MEETING NOTICE – SITE REVIEW COMMITTEE

RE: Founders Terrace, HB-524-2; New 11,873 Square Foot Commercial Building

ISSUE: Discussion and action on a new 11,873 square foot commercial building and associated site improvements

RE: Wash Shack Site Plan Application

SITE PLAN

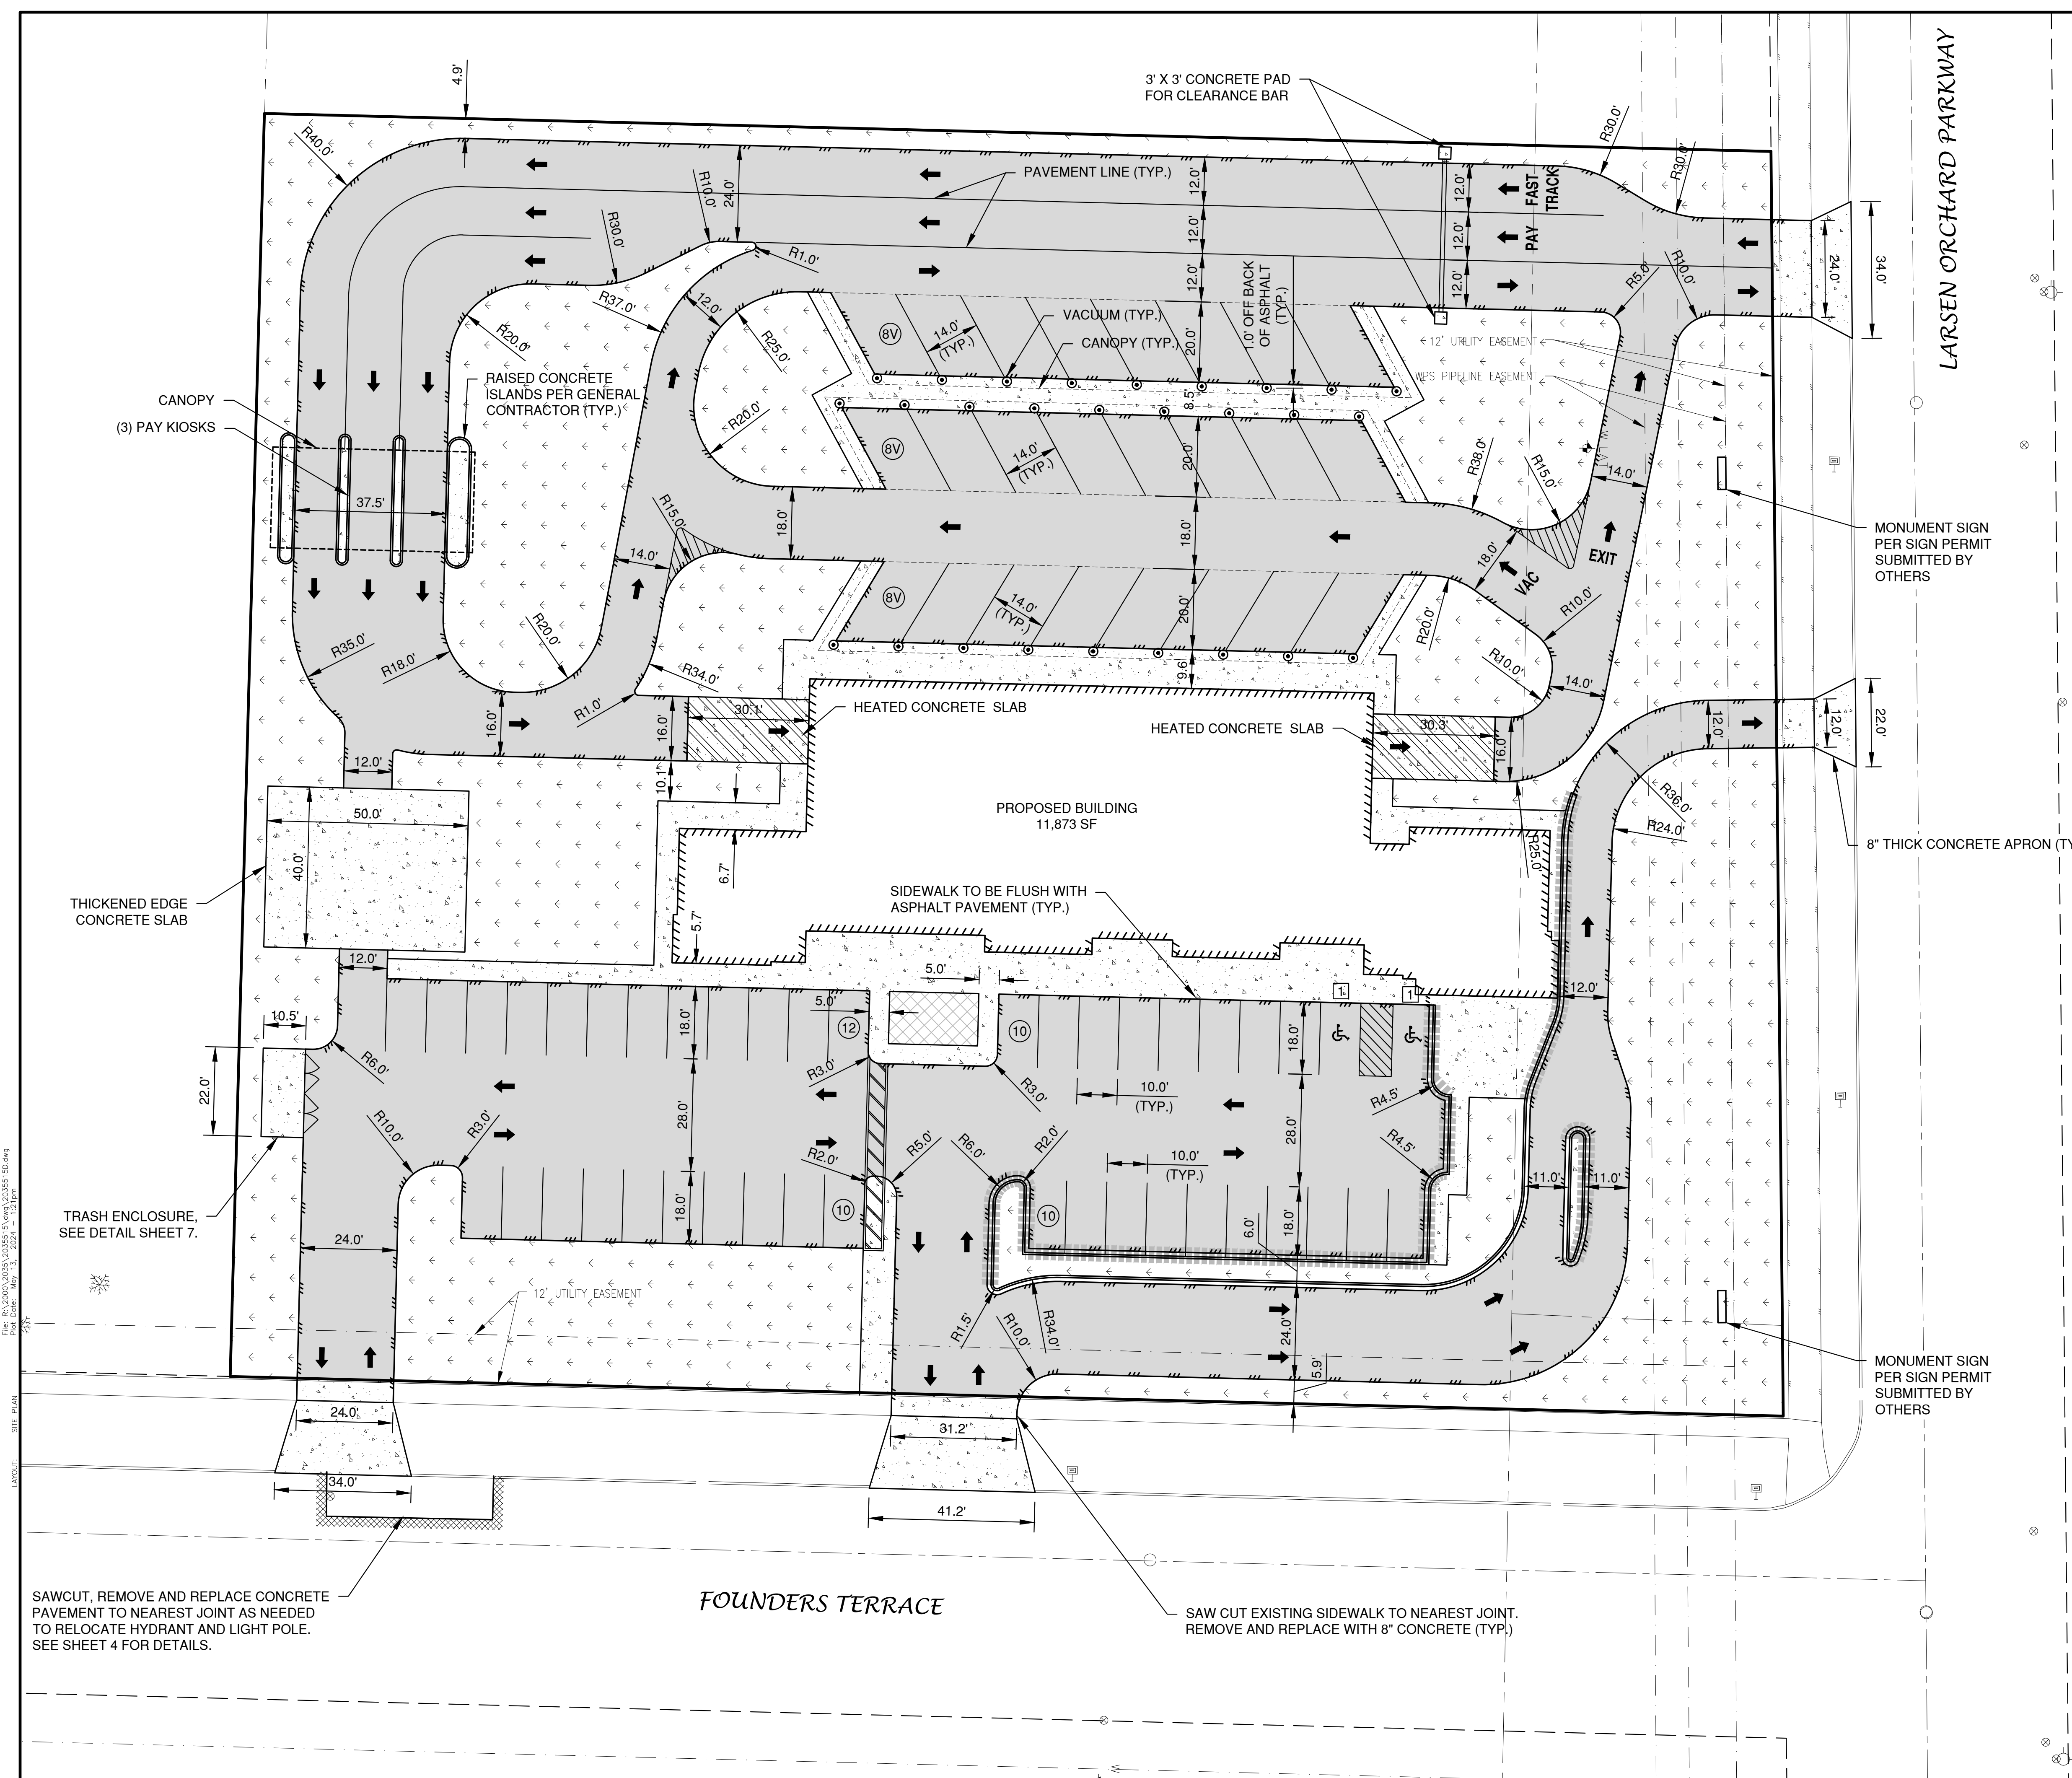
1. Increase width of paved driveway from 12' to 14' in southwest exit lane from center vacuum area
2. Add hydrant to west side of building in green area south of west vacuum area

3. Village hydrant relocation can be performed by onsite utility contractor under Village supervision and standards
4. Founders Terrace roadway concrete replacement will be full panel replacement approved by the Village and replaced per original roadway specifications

LANDSCAPE PLAN

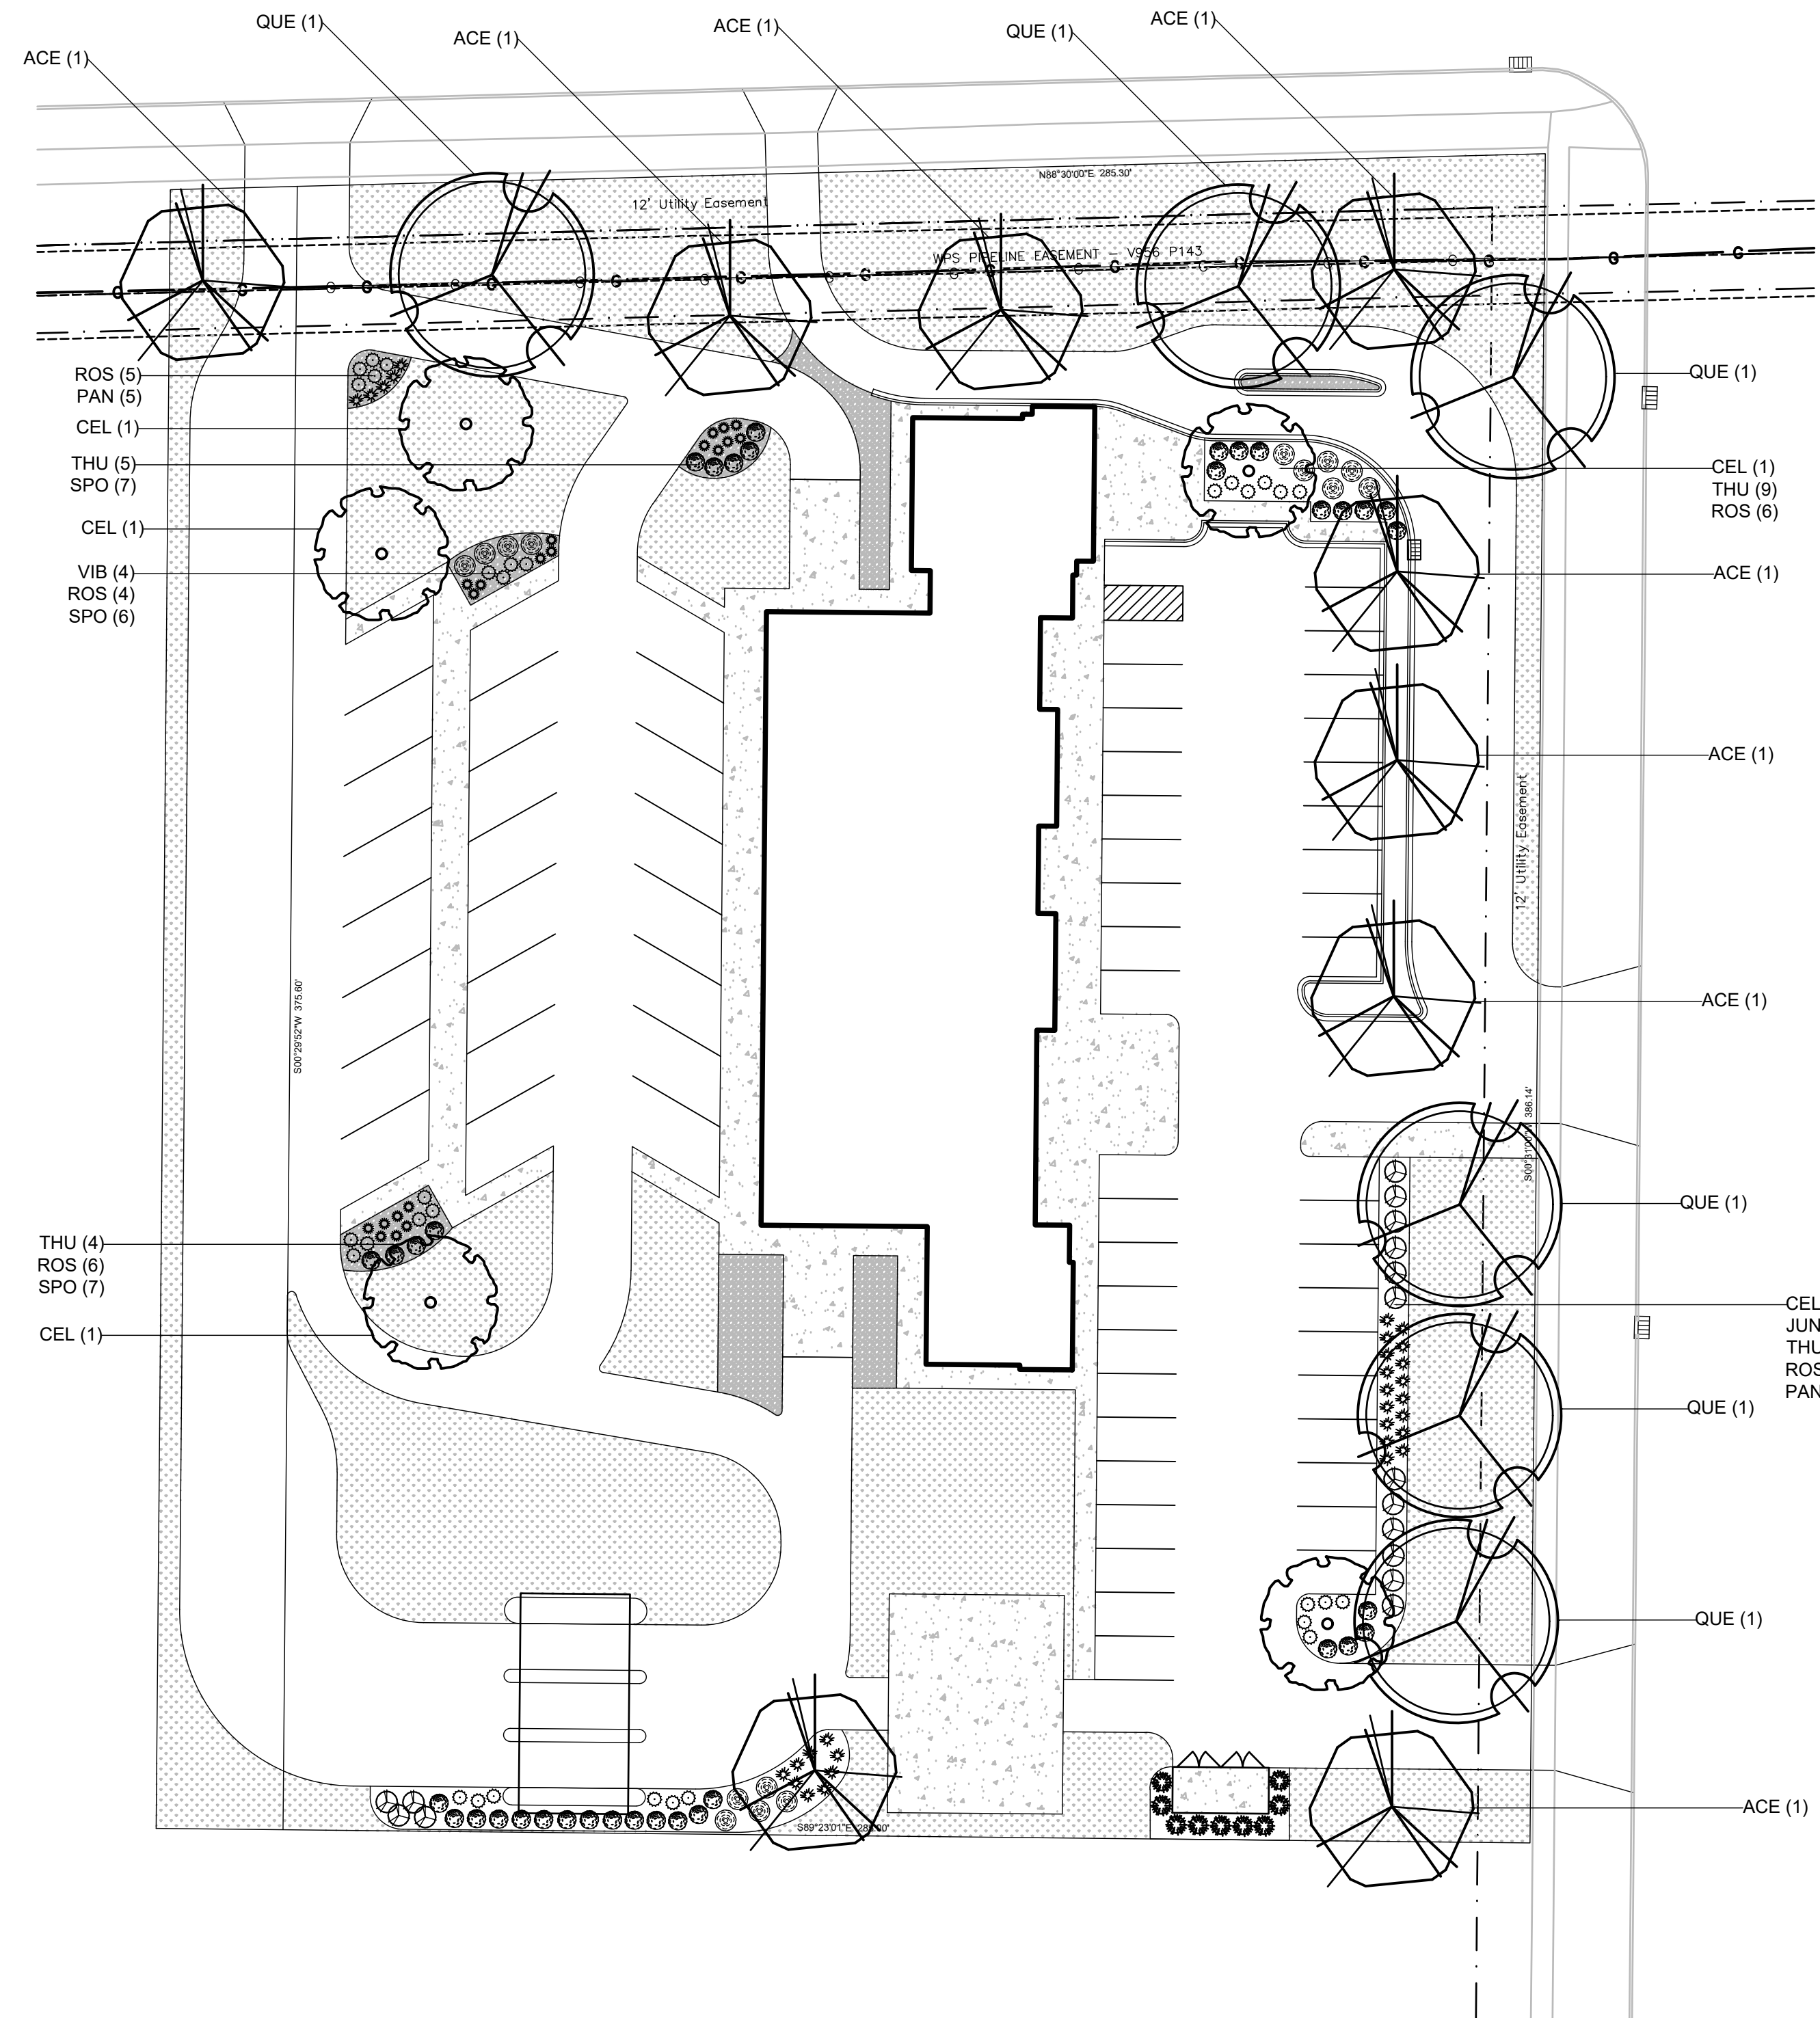
Section 3, Landscaping Plan: Required tree planting along the public roadway is noted on plan and foundation plantings along the office area and plantings screening portions of the parking areas are shown on the plan. It must be noted that the proposed trees along Centerline Dr. may need to be eliminated as there is a 20’ “gas line” easement that may exclude any plantings from being located within this area. The applicant is currently in the process of checking with WPS to get confirmation.

7. Alterations to the landscape plan following confirmation from WPS on the 20' gas line easement located along Centerline Dr. shall be approved by Village Staff. This may include the reduction in the number of trees located along Centerline Dr.
